VILLAWOOD

LEVEL 5 PLAN

Project no. 923 Dwg #. A106

DA - ADDITIONAL
INFORMATION

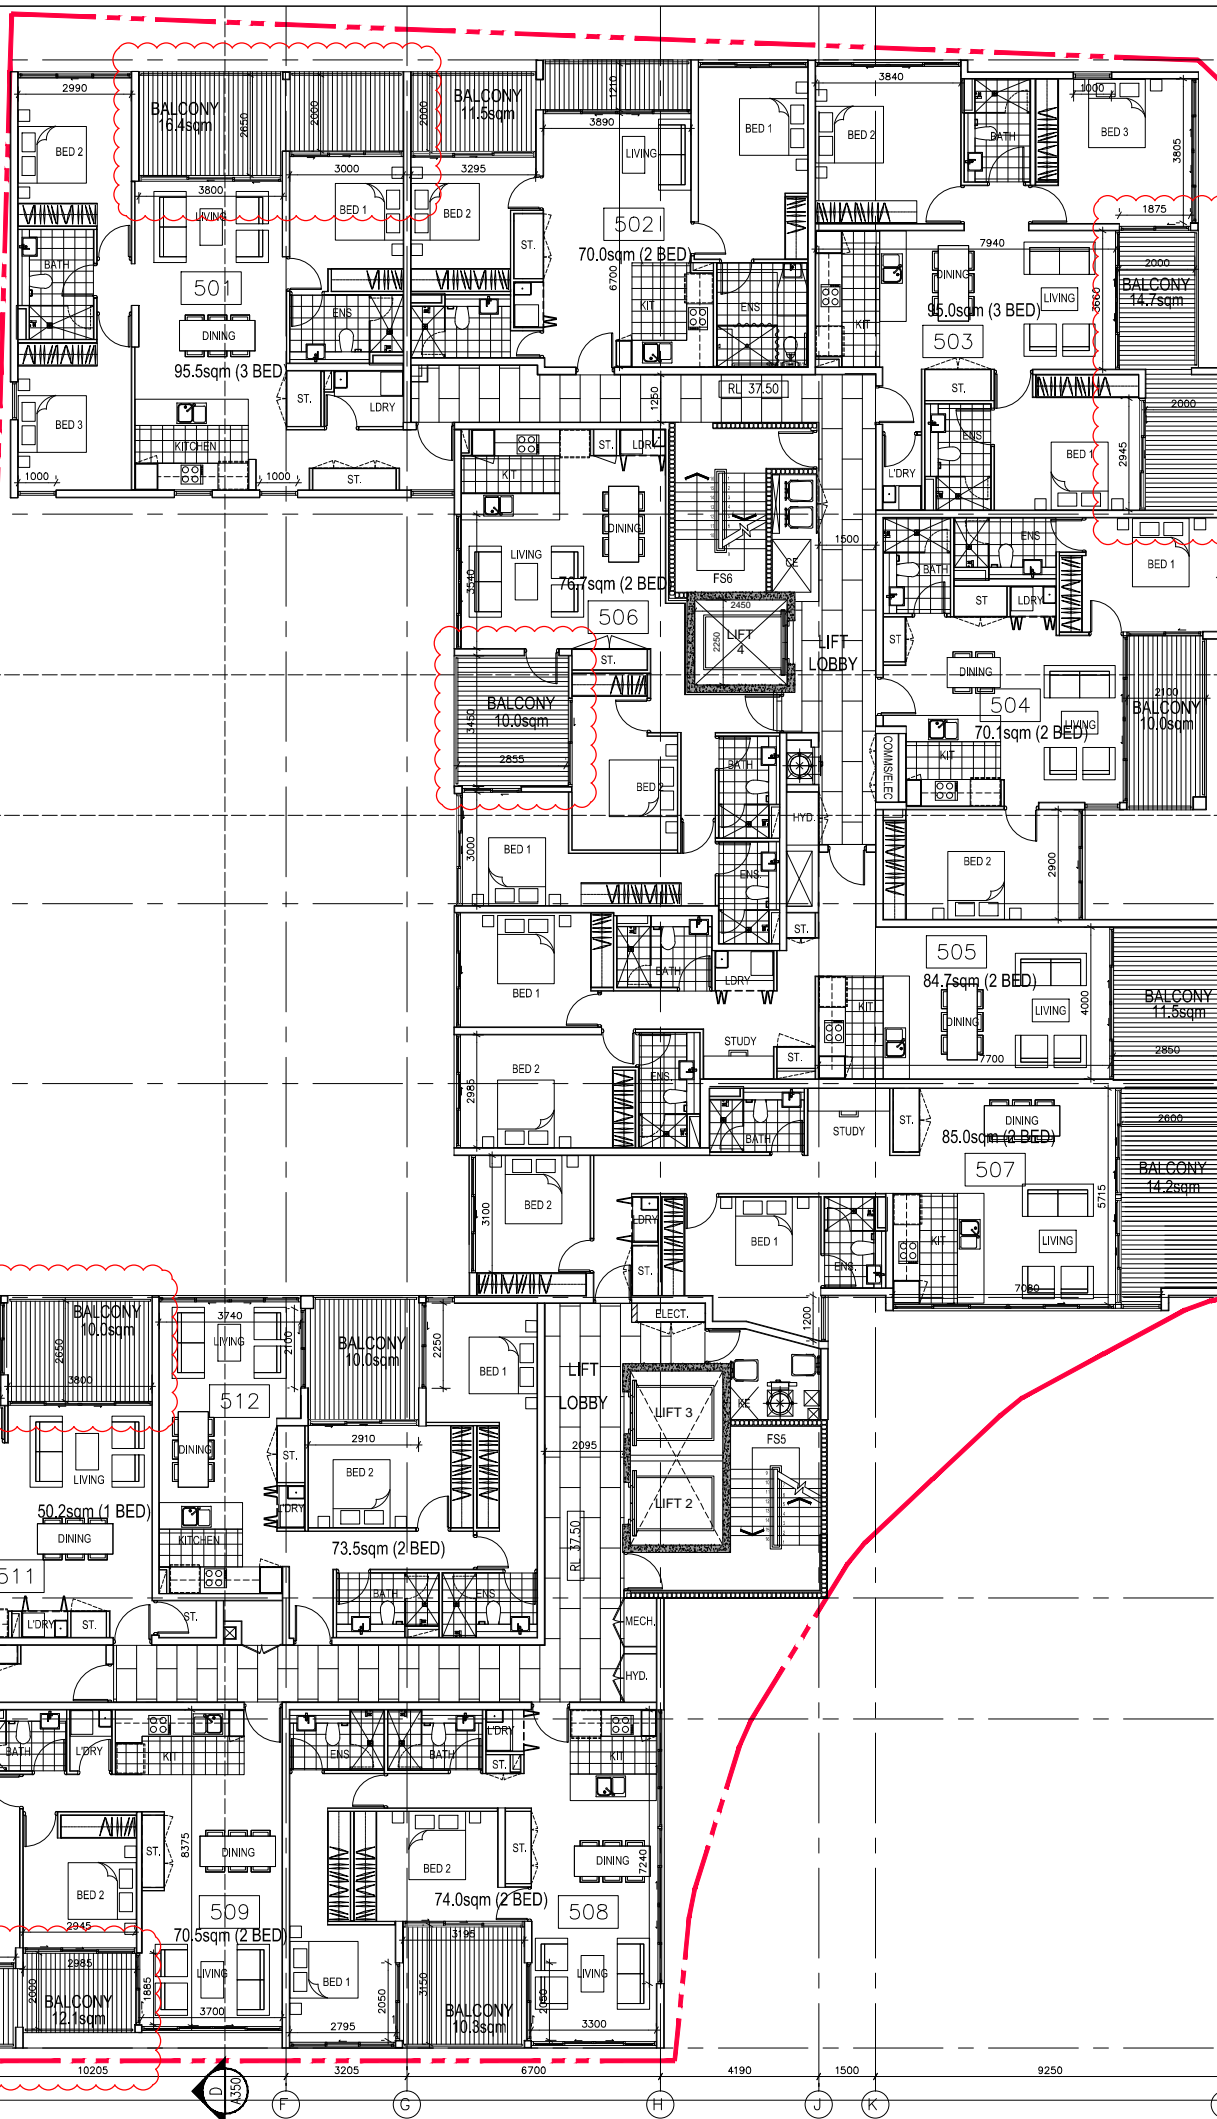
BALCONY DEPTH INCREASED TO
≥ 2 METERS IN DEPTH.
(AS SHOWN IN CLOUDED AREAS)
